HOLBORN TOWN HALL  
 193-197 HIGH HOLBORN

Sketch mark up.

SKT-0209798-7C-MH-20211122-Vent Strategy for GF&FF

# GROUND FLOOR

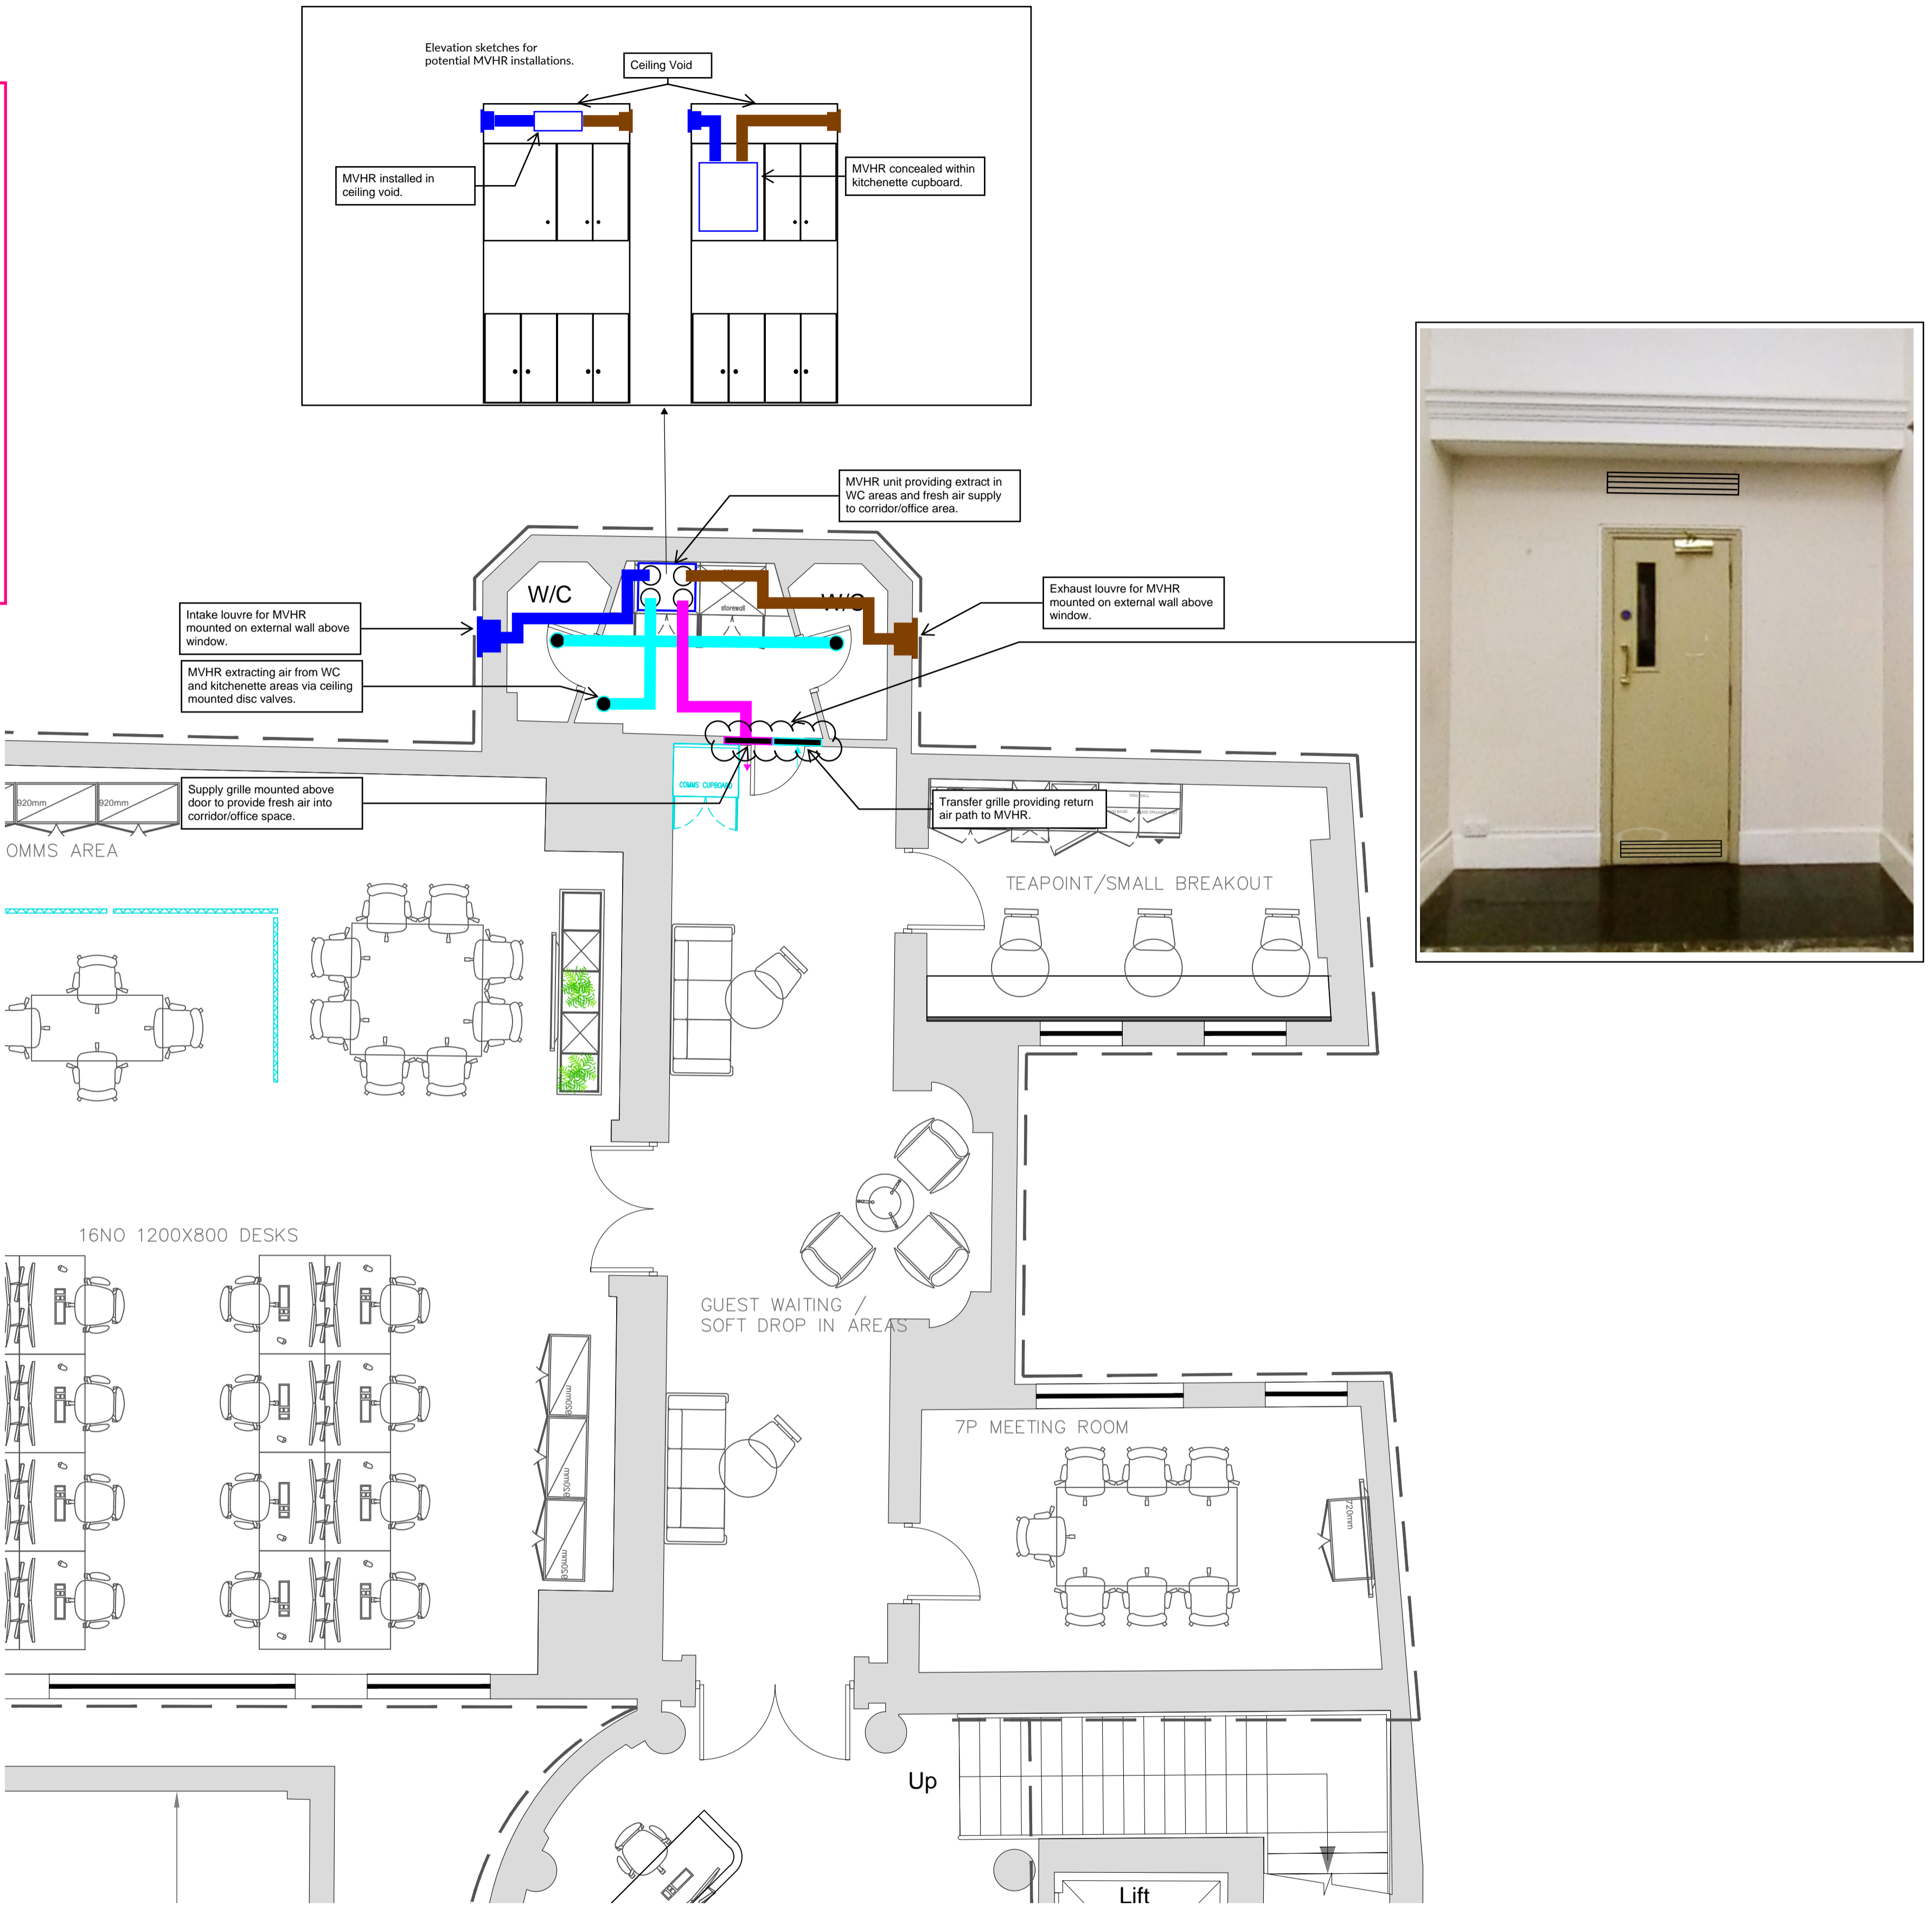
For the ground floor and first floor corridor areas to be used as occupied areas, a form of ventilation will be required to provide sufficient fresh air to the occupants within the area. Due to the age and condition of the windows in these corridors, it is assumed that using the corridor windows for natural ventilation or trickle ventilation systems has been ruled out. It is therefore suggested that mechanical ventilation is utilised for these two areas.

**Mechanical Ventilation Proposal**  
 It is proposed that the existing extract fans for the WCs on these two floors be removed and Mechanical ventilation via MVHR units be utilised to ventilate the WC and corridor areas. The strategy for this would be to supply fresh air to the desk areas in the corridor/halls while using the MVHR to extract foul air from the toilet and kitchenette areas. This would provide a degree of heat recovery and slight tempering to the fresh air being provided into the corridor areas. Two louvres per floor (one for exhaust and one for intake on ground and first floor respectively) would need to be installed on the external walls of the toilets as indicated. A supply grille as well as a return air/transfer grille would be needed in order to introduce air paths into the corridor/hall (refer to drawing for location of these grilles).

**Notes**  
 1) MVHR units could either be mounted within the ceiling void or concealed within a cupboard above the kitchen sink. A more thorough coordination exercise will need to be carried out for the feasibility of either option.  
 2) Grille types for the corridor area have not been specified, however grilles can be painted and chosen to in a way to blend in with the fabric as much as possible.

# FIRST FLOOR

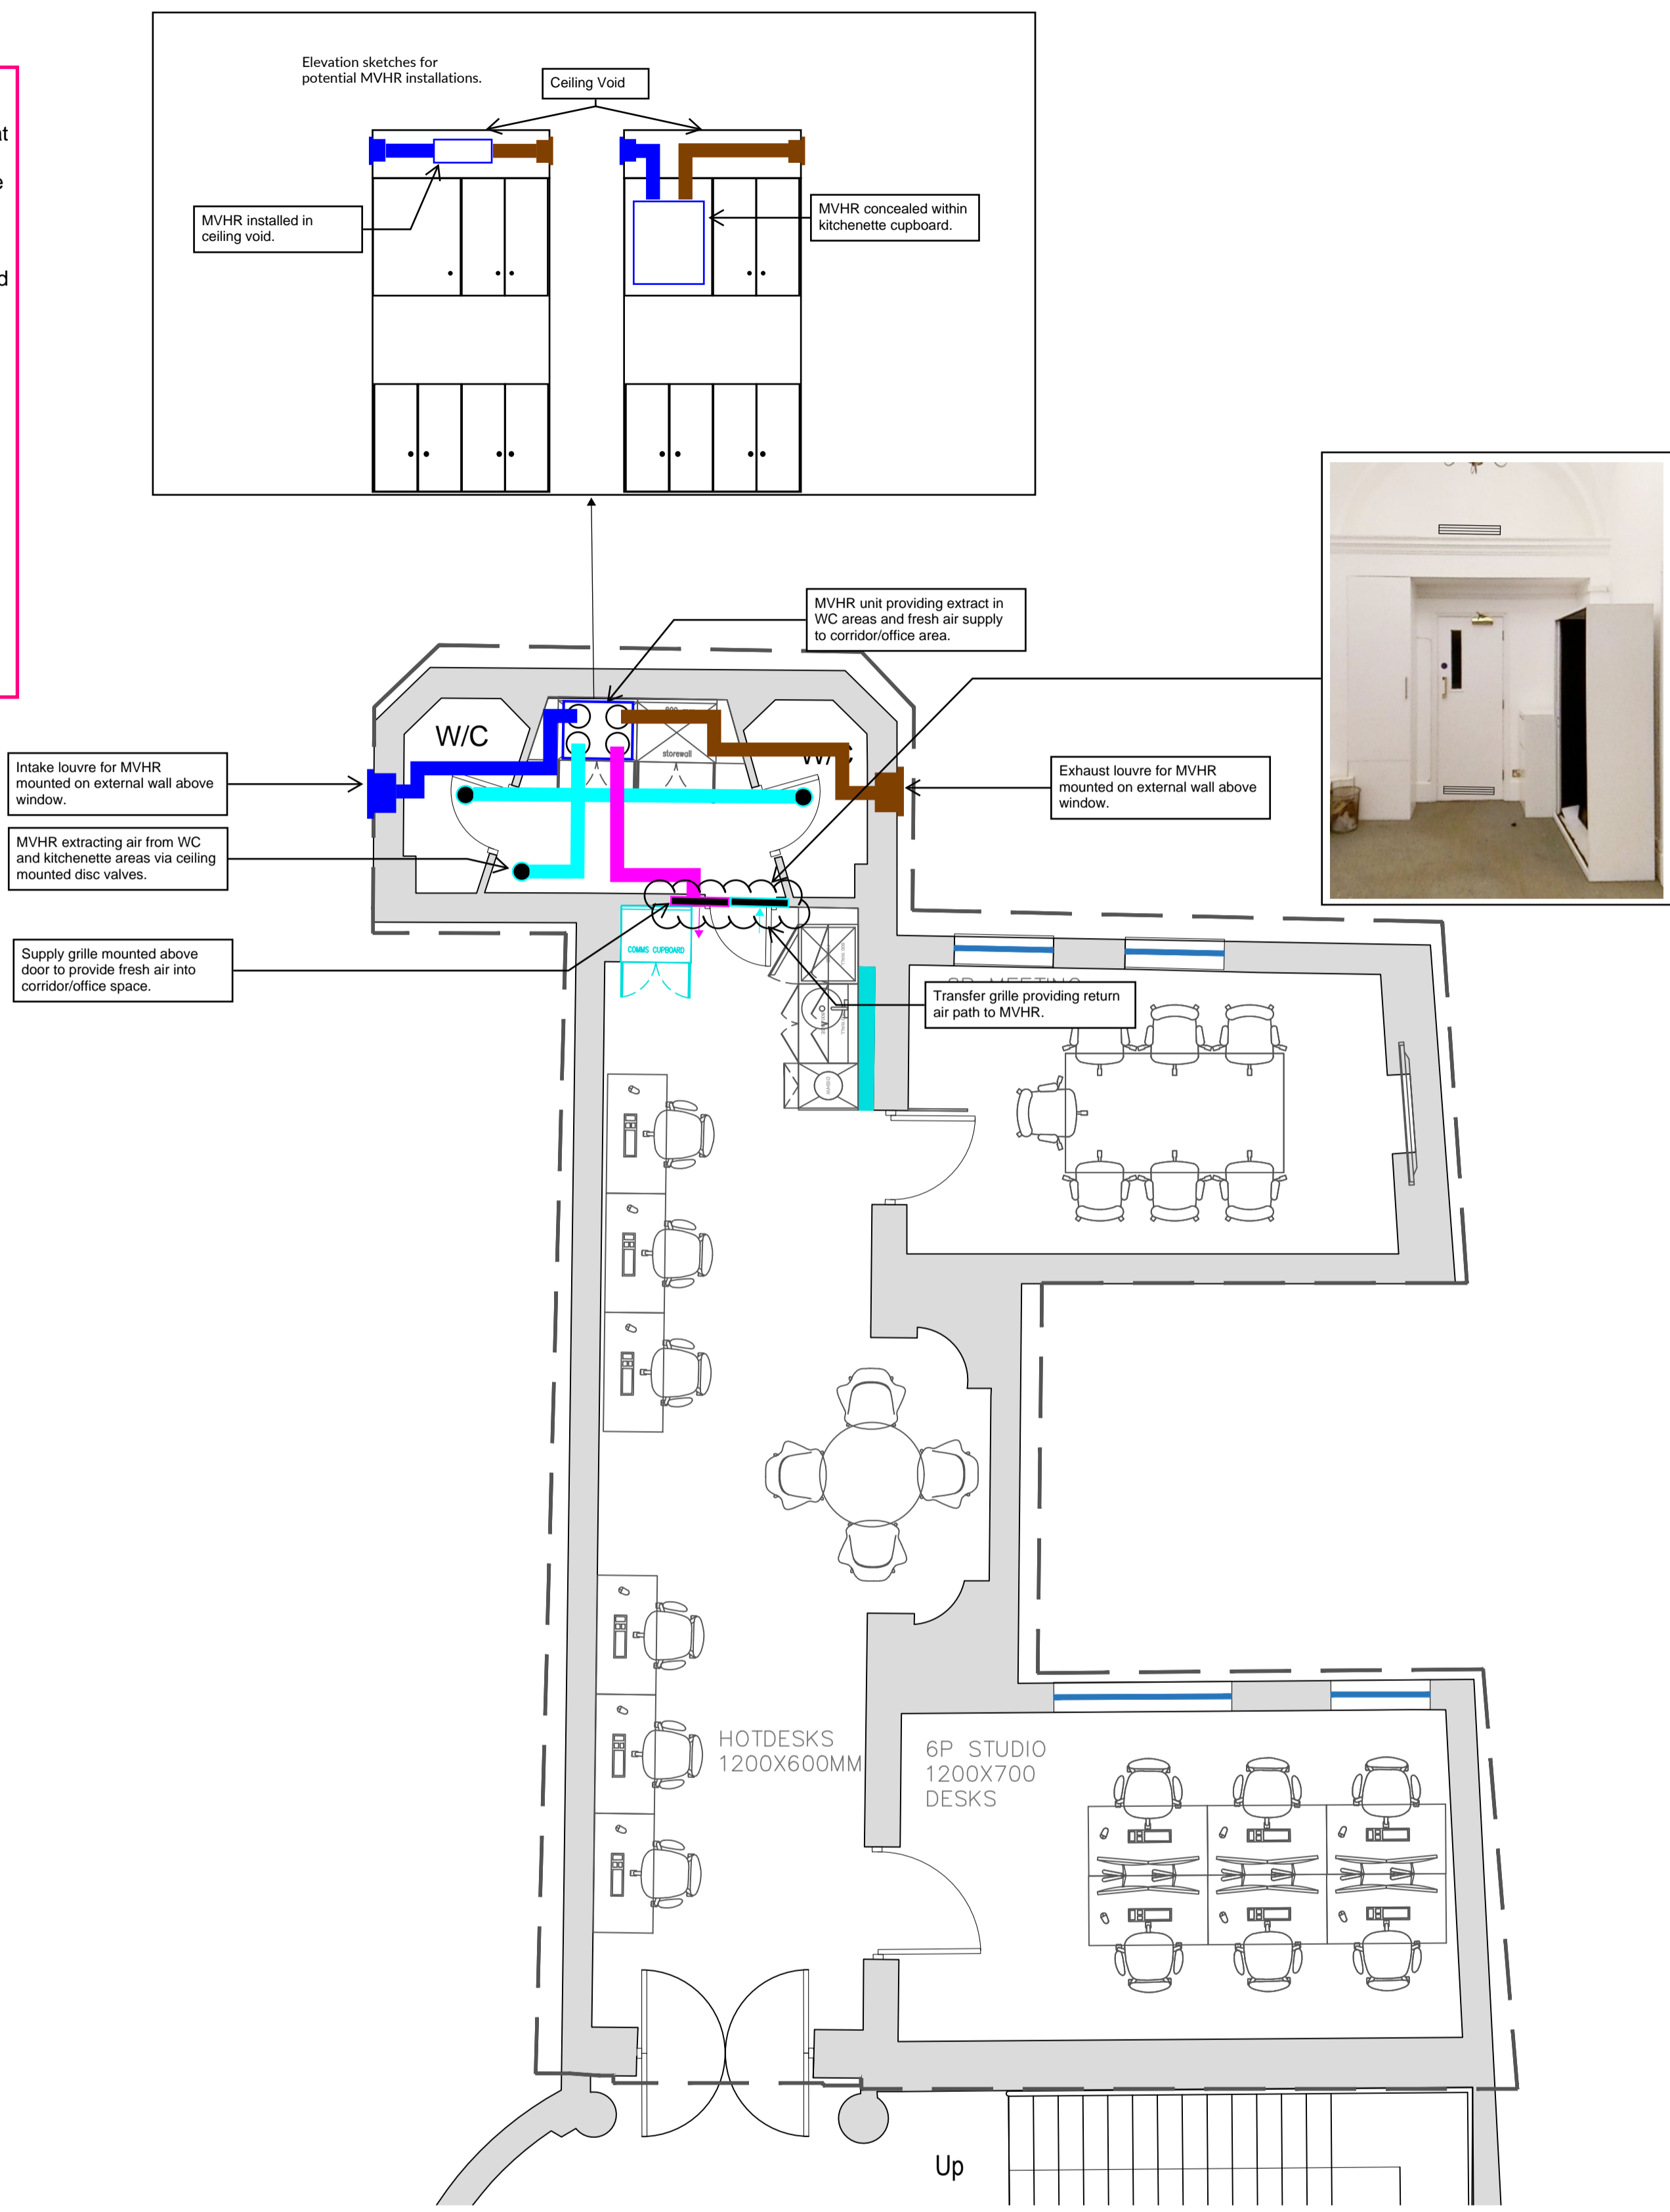
For the ground floor and first floor corridor areas to be used as occupied areas, a form of ventilation will be required to provide sufficient fresh air to the occupants within the area. Due to the age and condition of the windows in these corridors, it is assumed that using the corridor windows for natural ventilation or trickle ventilation systems has been ruled out. It is therefore suggested that mechanical ventilation is utilised for these two areas.

**Mechanical Ventilation Proposal**  
 It is proposed that the existing extract fans for the WCs on these two floors be removed and Mechanical ventilation via MVHR units be utilised to ventilate the WC and corridor areas. The strategy for this would be to supply fresh air to the desk areas in the corridor/halls while using the MVHR to extract foul air from the toilet and kitchenette areas. This would provide a degree of heat recovery and slight tempering to the fresh air being provided into the corridor areas. Two louvres per floor (one for exhaust and one for intake on ground and first floor respectively) would need to be installed on the external walls of the toilets as indicated. A supply grille as well as a return air/transfer grille would be needed in order to introduce air paths into the corridor/hall (refer to drawing for location of these grilles).

**Notes**  
 1) MVHR units could either be mounted within the ceiling void or concealed within a cupboard above the kitchen sink. A more thorough coordination exercise will need to be carried out for the feasibility of either option.  
 2) Grille types for the corridor area have not been specified, however grilles can be painted and chosen to in a way to blend in with the fabric as much as possible.
